CITY OF CEDARBURG
A MEETING OF THE SITE AND ARCHITECTURAL REVIEW BOARD
TUESDAY, DECEMBER 23, 2025 – 8:30 AM

CITY OF CEDARBURG
Site and Architectural Review Board
November 18, 2025

PLANNER REPORT

Request: Favorable recommendation to the Plan Commission for Planned Unit Development Overlay rezoning based upon the revised concept presented for a seven lot/home single-family-detached residential infill development.

I SITE PLAN
 1" = 50'-0"

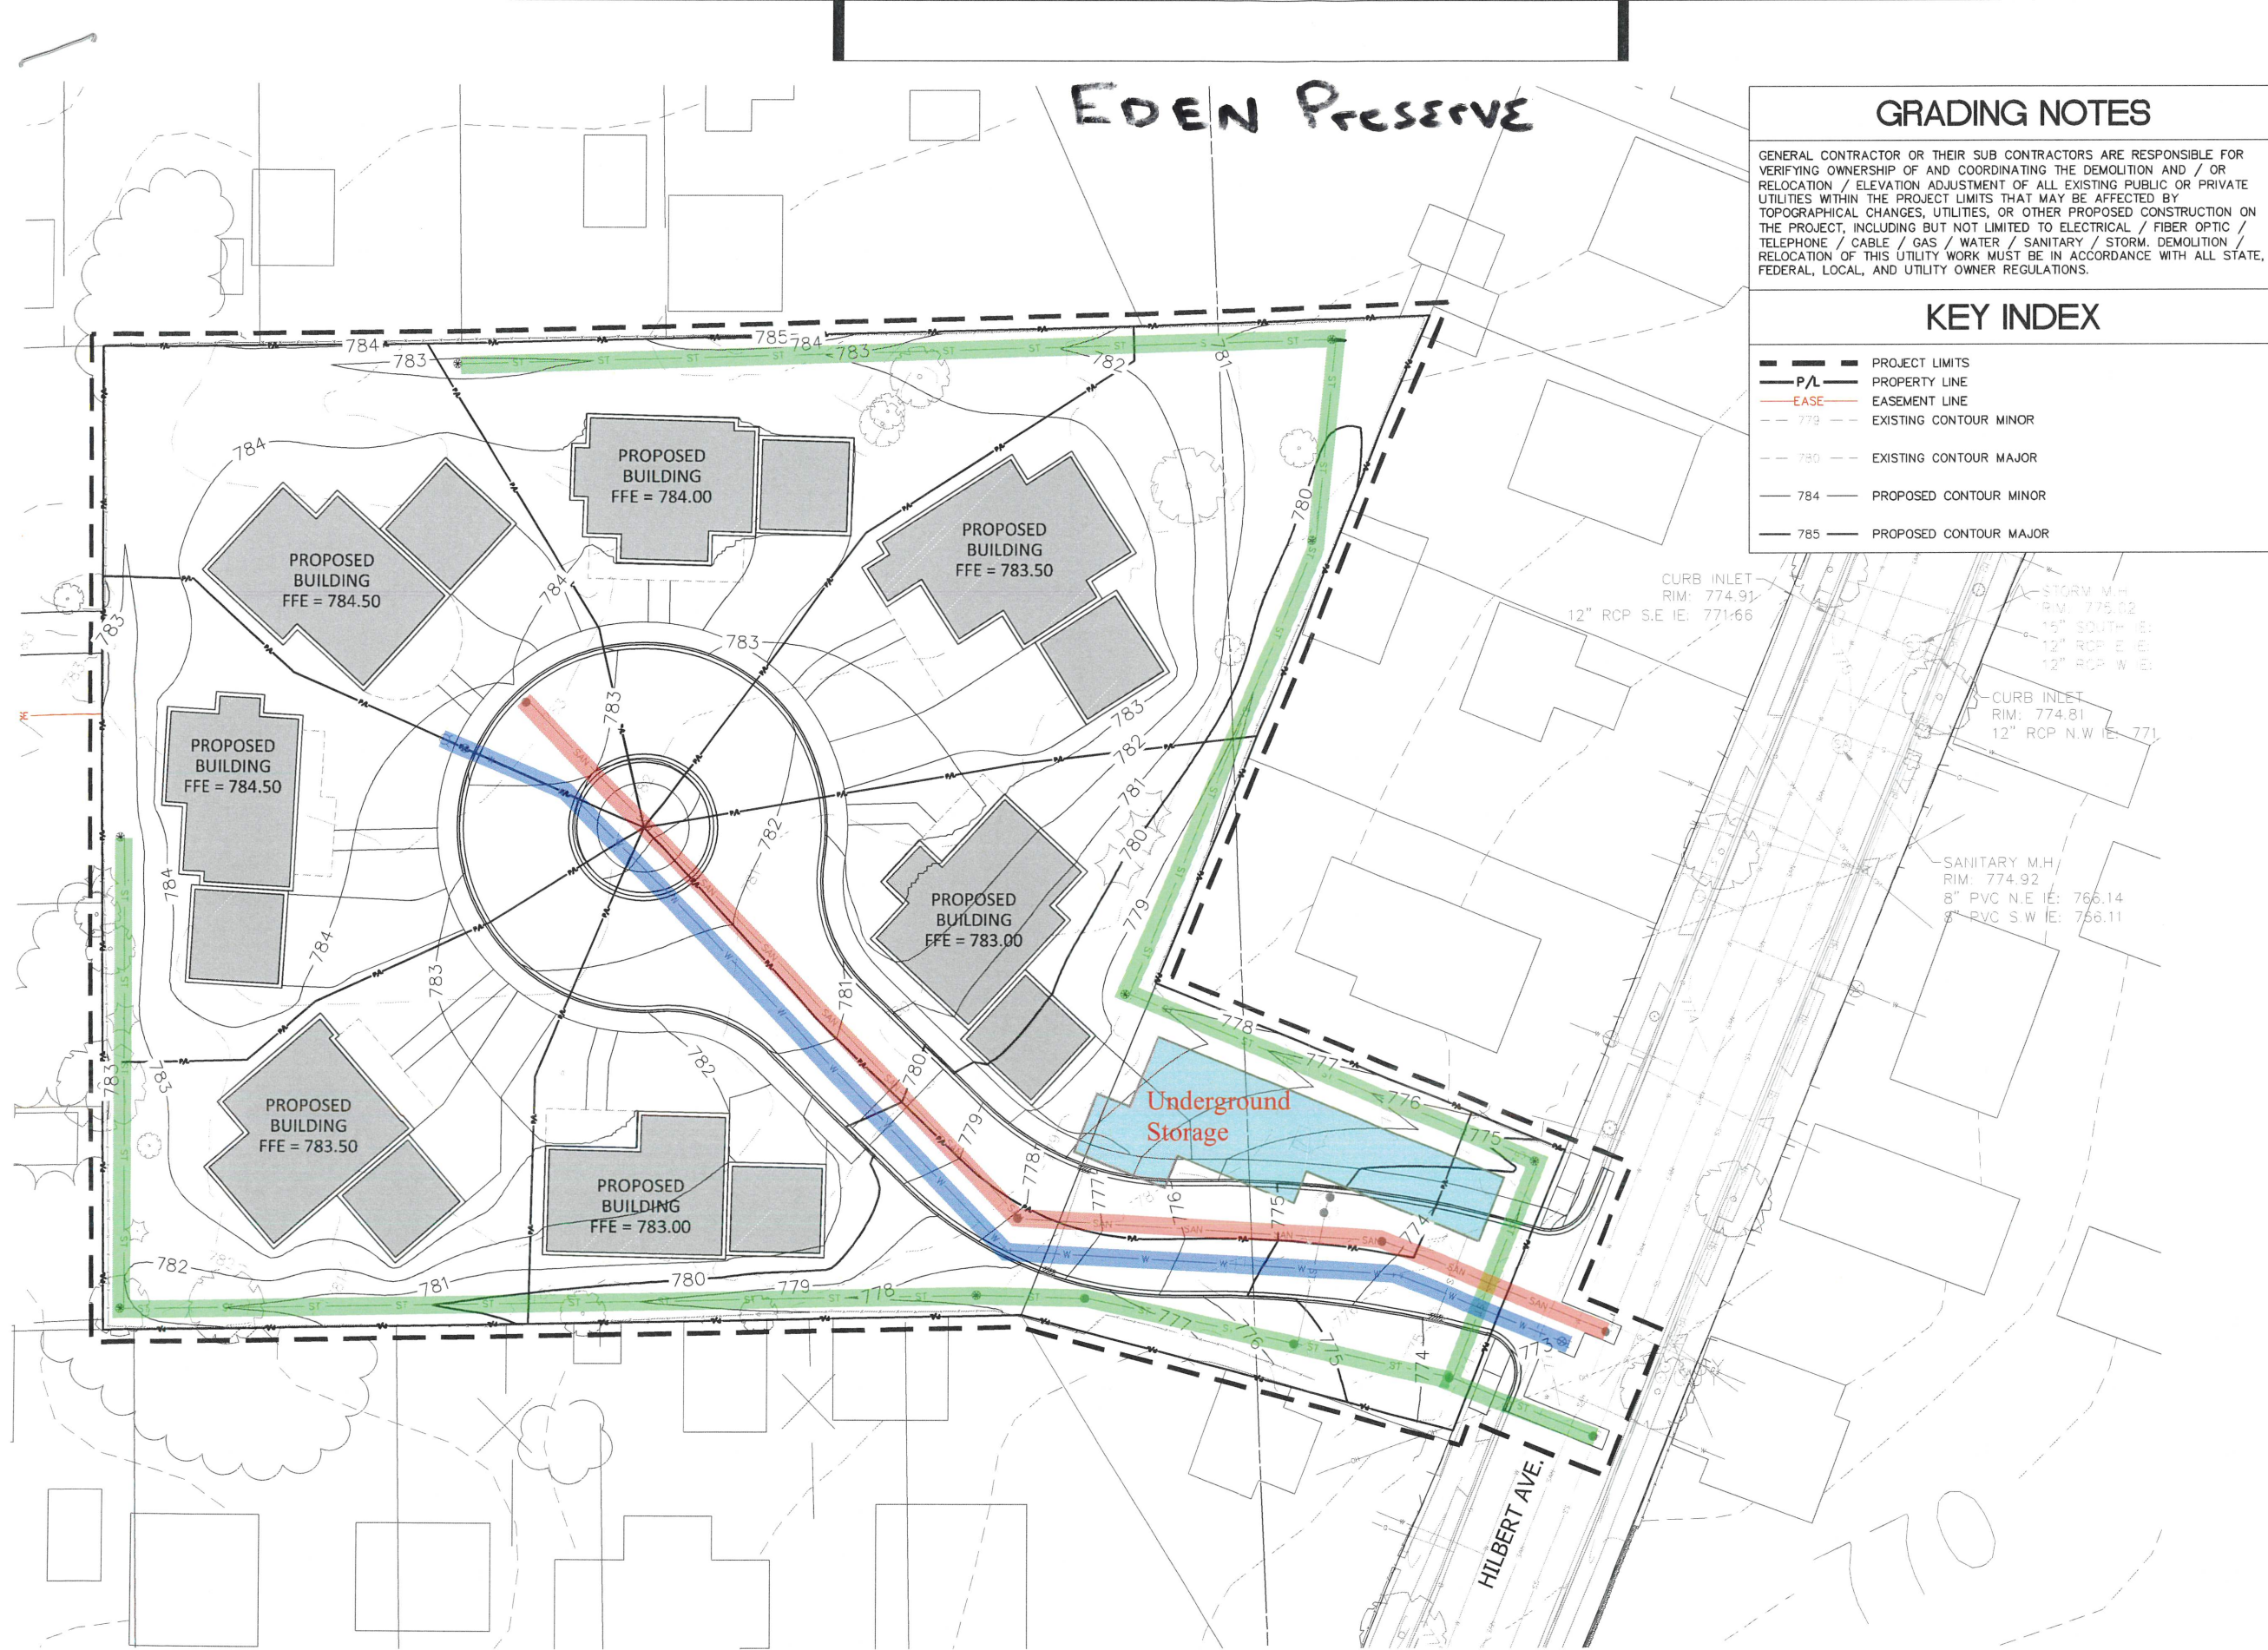
The applicant presents a revised seven lot/home single-family-detached residential Planned Unit Development for this site. The plan still depicts a private cul de sac drive with curb, gutter, and sidewalks, entering off of Hilbert Avenue. There are no longer any communal improvements located at the entry area such as fountain, pergola, trellis, pillars, or community building. There is no longer any plan to develop a public or private pedestrian walkway (i.e., a promenade) extending west from the proposed new cul de sac out to Washington Avenue. The project has been renamed to Eden Preserve.

The plan still contains seven lots. Instead of having the private road and sidewalks situated in an Outlot owned, in equal shares, by the owners of the seven lots, the plan now shows each lot boundary extending to the centerline of the road. The effect of this is to make the new lot sizes larger, in fact. A concern with this approach is who will write, review and approve the critical easements needed from each individual owner, granting to each other owner, the public, the City,... pedestrian and driving access over the street and sidewalk, access to the City for service/repair/replacement of the public utilities such as sanitary sewer and water that will lie beneath the private drive, access to the tentatively planned underground stormwater management tank on Lot 1. This also means that any street lights and/or street trees as may be required by the City will be located on the various owners private lots.

With these ‘larger’ lot sizes, the applicant now lists proposed floor area ratios compliant with the maximum permitted in the Rs-5 district (i.e., maximum allowed 36%) vs all but 1 lot being over the FAR in the original plan. Proposed home sizes in the plan range from 2,450 – 3,700 sq. ft., plus porches and garages. All homes now include attached garages. The homes are proposed to be custom designed and built for each individual lot buyer. Fully detailed architectural standards for the subdivision have not been presented at this time.

Minimum required lot size in the Rs-5 zoning district is 8,400 sq. ft. in area and 50 feet in width. The proposed lot sizes in the new plan range from 9,788 – 11,902 sq. ft., vs 6,300 – 11,000 in the original plan. As with the previous plan, none of the new lots will have 30

A clear recommendation is also requested pertaining to the extension of lot lines to the center of the road vs having the private street/sidewalk situated in an Outlot as was originally proposed. The Planning, Engineering and Utility staff are all wary of this approach without specific legal guidance to support it. If an Outlot solution is used, the lot sizes might all require PUD exceptions. Would you support such lot size exceptions thorough PUD?
Yes/No
